# UNITED STATES PATENT AND TRADEMARK OFFICE

APPLICATION NO.	FILING DATE	FIRST NAMED INVENTOR	ATTORNEY DOCKET NO.	CONFIRMATION NO.
10/509,434	06/06/2005	Tony Day	026808-002800US	7437

<b>Office Action Summary</b>	<b>Application No.</b> 10/509,434	<b>Applicant(s)</b> DAY, TONY	
	<b>Examiner</b> HELENA KOSANOVIC	<b>Art Unit</b> 3749

## DETAILED ACTION

(fig. 4 of Ledbetter)

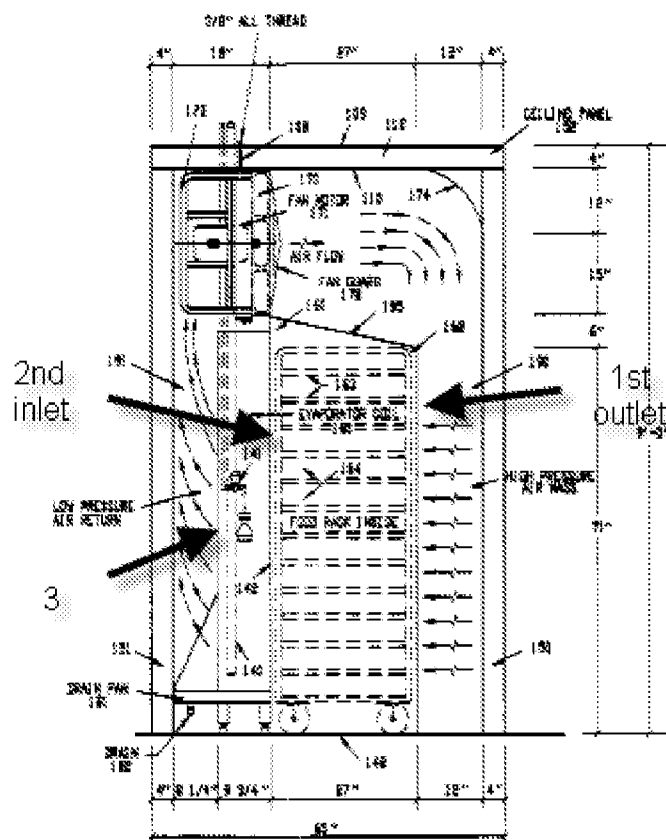
Ledbetter teaches an invention as claimed: a substantially sealed airtight cabinet (fig. 4) sized for housing vertical array of heat-producing units 162 having an exterior

shell 109,190,151, an interior divider wall 160 disposed inside the cabinet wherein the shell and the divider wall provide an equipment chamber 164, 163, with a first plenum 190 and a first inlet 172 defined by the divider as an at least one substantially vertical slot, admitting the air uniformly over a substantial vertical length (fig. 4), wherein the divider wall is configured such that the first inlet at least partially vertically overlaps with first plenum 190 (fig. 4) ; said shell and divider wall providing a heat exchanger chamber (on the right sight from divider wall 160) in which the heat exchanger 180 is disposed and an equipment chamber (on the left side from dividing wall 160) separate from the heat exchanger chamber (fig. 4); a first outlet 1 (see paragraph 16 bellow of this Office Action, wherein examiner marked originally not marked first outlet 1 with darkened arrow for clarification) wherein the first plenum communicates with the openings for exhausting substantially all of the flow through the array in substantially horizontal direction (fig. 4); a second plenum 191 defined between the chamber shell and the array for receiving the air that has passed through the array having a second inlet 2 (see paragraph 16 bellow of this Office Action, wherein examiner marked originally not marked second inlet 2 with darkened arrow for clarification) and second outlet 3 (see paragraph 16 bellow of this Office Action wherein examiner marked originally not marked second outlet 3 with darkened arrow for clarification) defined by the divider wall such that the air is directed horizontally (fig. 4) from equipment chamber 164,163; a heat transfer means 180 (col. 6, ll. 21-25) disposed in the cabinet for carrying heat away from the cabinet; a door 210 (fig. 7) configured to provide selective access to the heat-producing units based on at least one of an environmental compatibility inside and

Regarding claims 52 and 56 they are also rejected based on the consideration of the first inlet, first air plenum and first air outlet as shown in paragraph 6 of this Office Action. First inlet 1 described as first outlet in discussion above, with first air plenum 1' and first outlet 1" wherein the first inlet extends substantially a full vertical extent of at least one of the array and the first plenum.

Ledbetter teaches an invention as discussed above and further: a mechanism 173,180 for cooling and recirculation of the air between mechanism chamber 191 (fig. 4) and equipment chamber 163,164, wherein the shell and divider wall are configured to direct the air to the mechanism that may have at least one fan (fig. 16) positioned downstream from the fan wherein the flow of the air through equipment chamber 163,164 is substantially parallel to and opposed to the flow of the air through mechanism chamber 191 (fig. 4);

6. Examiner marked originally unmarked elements with darkened arrows for clarification.
